July 31, 1985
LD-85-034

Subject: CESSAR System 80" Technical Specification Review

RESPONSES TO NRC QUESTIONS ON CESSAR TECHNICAL SPECIFICATIONS

TABLE 2.2-1

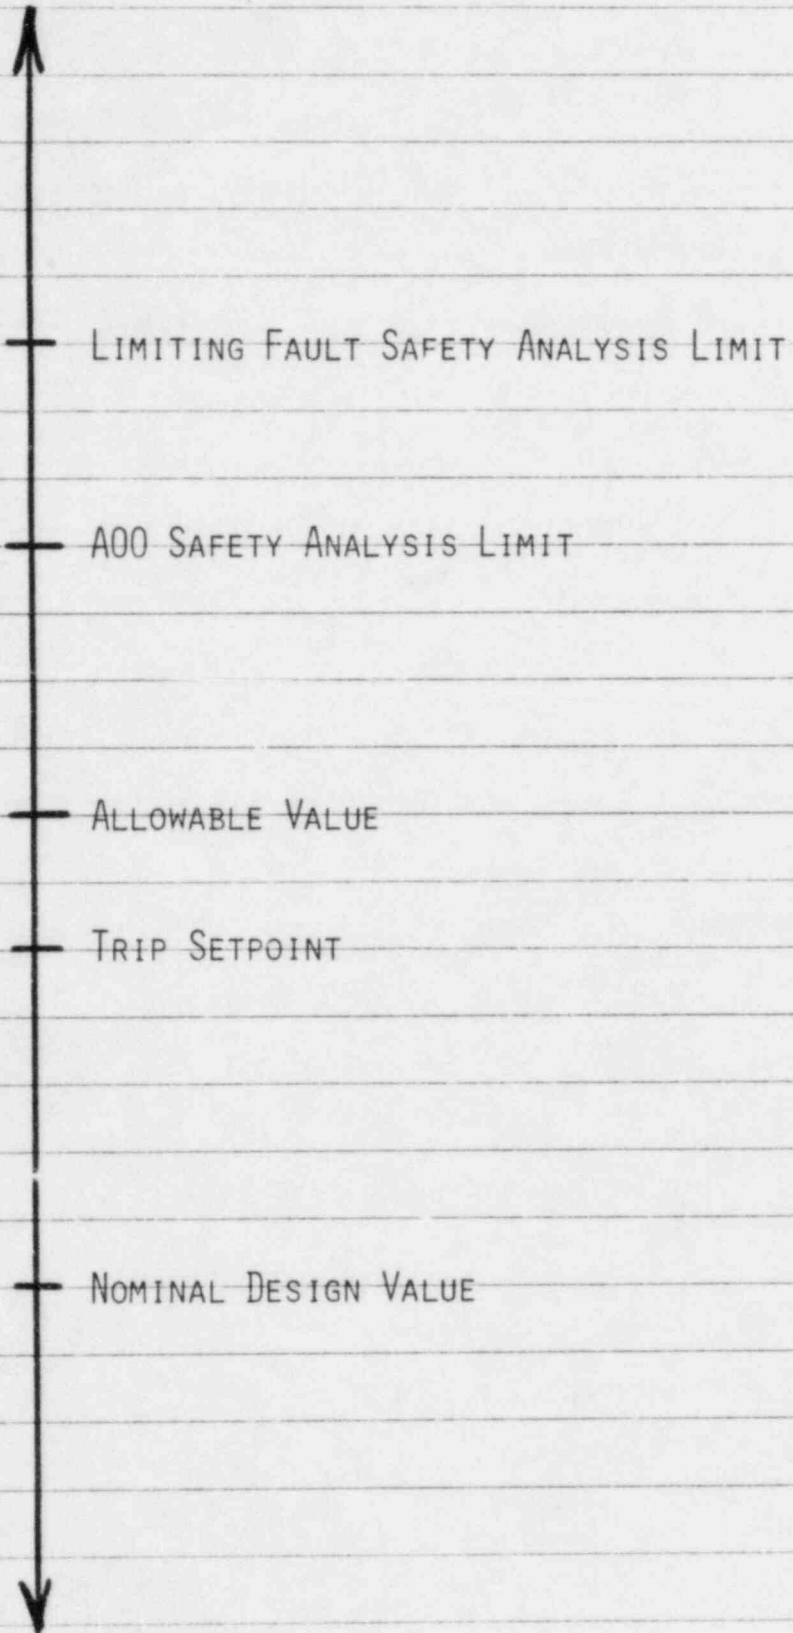
Provide the appropriate numbers in Tables 2.2-1, 3.3-2, 3.3-4 and 3.3-5 of the CESSAR System 80 Tech Specs which were used in the CESSAR Chapter 15 accident analyses.

The enclosed marked-up page from Palo Verde tech specs Table 2.2-1 shows the table as C-E would prepare it for System 80, according to the suggestion mentioned above. Multiple values appear because different transient-specific environmental effects and acceptance criteria result in different safety analysis setpoints. (In a specific applicant's technical specifications, the more restrictive trip setpoint value resulting from the various safety analysis

As an alternate suggestion, C-E recommends that the System 80 Tech Specs refer the reviewer to the Applicants SAR for Table 2.2-1 (and, by extension, Tables 3.3-2, 3.3-4 and 3.3-5). C-E believes the review process should entail only plant-specific documentation.
